MANDARIN DEVELOPMENTS PTY LTD

BCA ASSESSMENT REPORT

61A-65 Albert Avenue, Chatswood

Project number: 251547
Revision: BCA 1.0
Date: 17 December 2025

Figure 3 - Ground Floor residential lobby

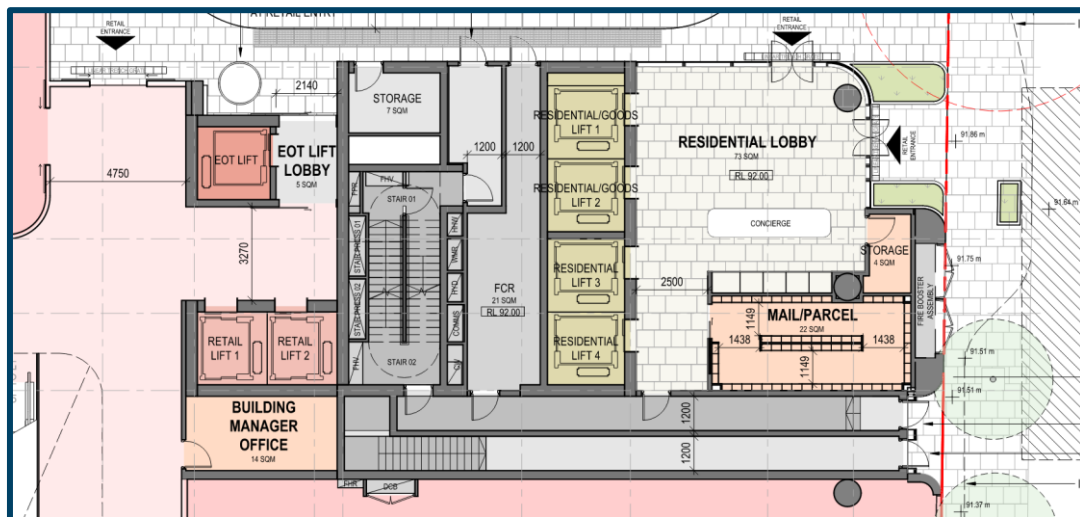
A Fire Engineered Performance Solution is required to address the Class 6 & 9b fire compartment, as the Ground Floor to Level Two compartment will be greater the 5000m² as permitted by Clause C3D3. In addition, a Fire Engineered Performance Solution will be required to address to proposed glazed opening within the Class2 and Class 6 lobbies as separation between classifications.

Figure 4 – Level 5 floor layout

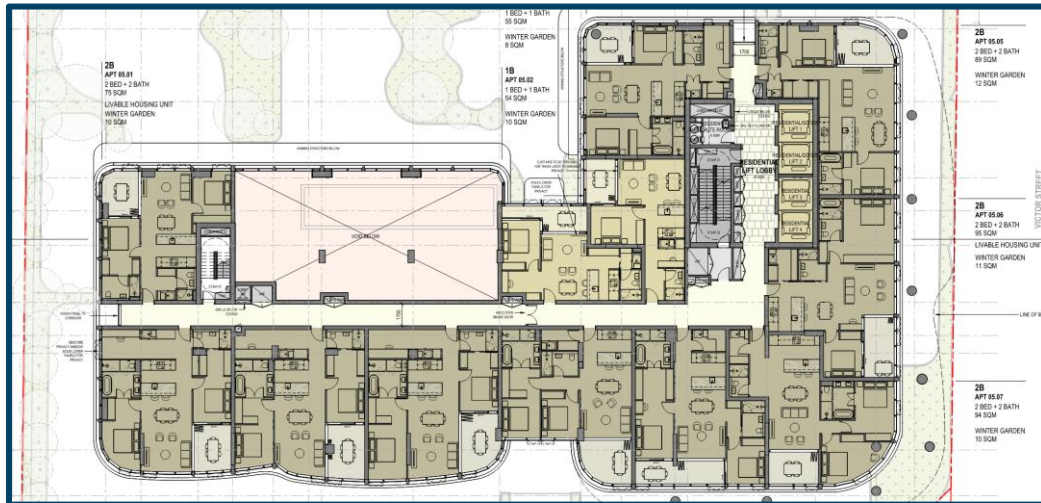
An additional Fire Engineered Performance Solution will be required To permit the Class 2 corridor lengths within the building the building to be greater than forty (40) metres

Note: The smoke door is also required to swing in the direction of egress in accordance with BCA Clause D3D25.

Due to the location of the exits being on opposite ends of the residential corridor, the smoke door would be required to swing in both directions to comply with BCA Clause D3D25. However, this poses a smoke leakage issue with the smoke door.

Therefore, a Fire Engineered Performance Solution is required to address either the smoke door not swinging in the direction of egress or where the smoke door has a smoke leakage issue due to the bidirectional swing.

Figure 5 - The FCR for the development

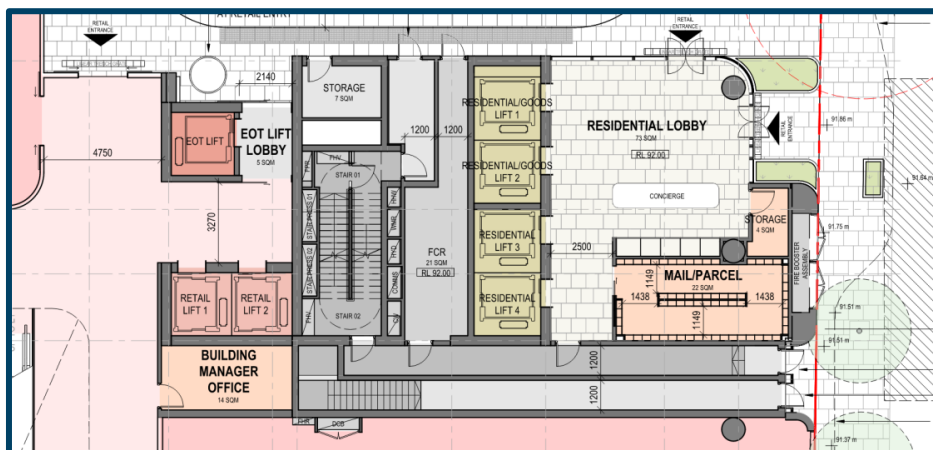
The proposed door within Stair 1 is non-compliant, as the door currently opens up more than 100 mm into a *required exit* as per Clause D3D25. It is recommended that the door from the fire-isolated stair open into the room as per Specification 19, Clause 9.

Figure 6 - The Level 26 SOUs affected

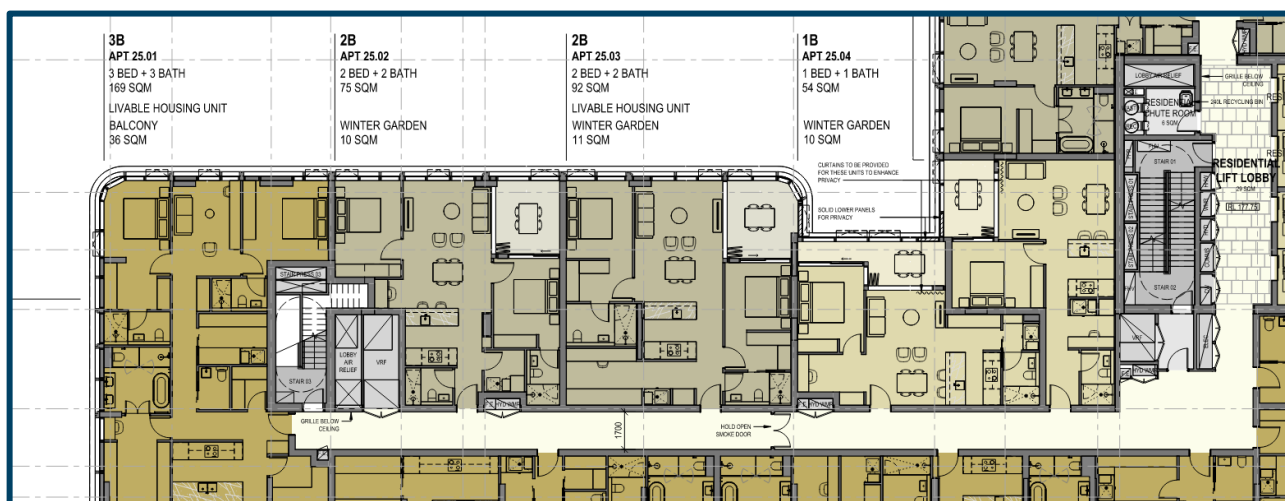
Furthermore, a Fire Engineered Performance Solution is required to address the extended hydrant coverage to SOUs on Level 26, due to the two (2) storey SOUs.

Figure 7 - Level 29 where lifts 3 & 4 stop

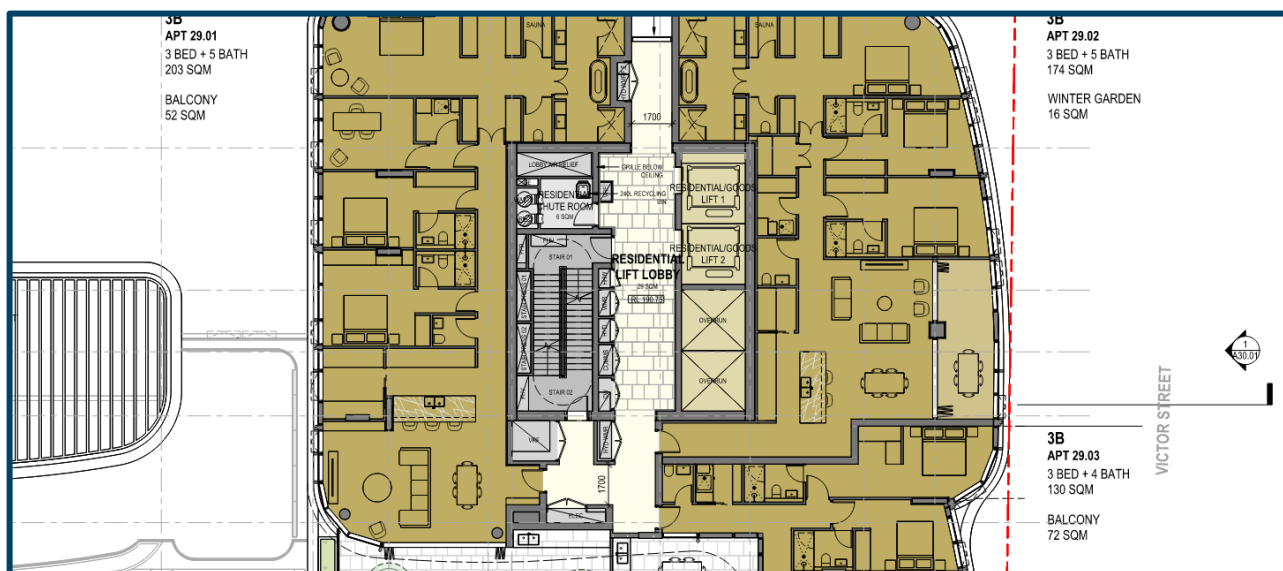
Where buildings exceed twenty-five (25) metres effective height, the building is required to have one (1) emergency lift installed. A Fire Engineered Performance Solution is required prior to issuing the Construction Certificate to address the following issues within the building:

- + To delete the requirement for an emergency lift that does not serve a *storey* more than twenty-five (25) metres in effective height.
- + To permit one (1) emergency lift to serve the most upper floor, as lifts 3 & 4 do not serve levels 29 & 30
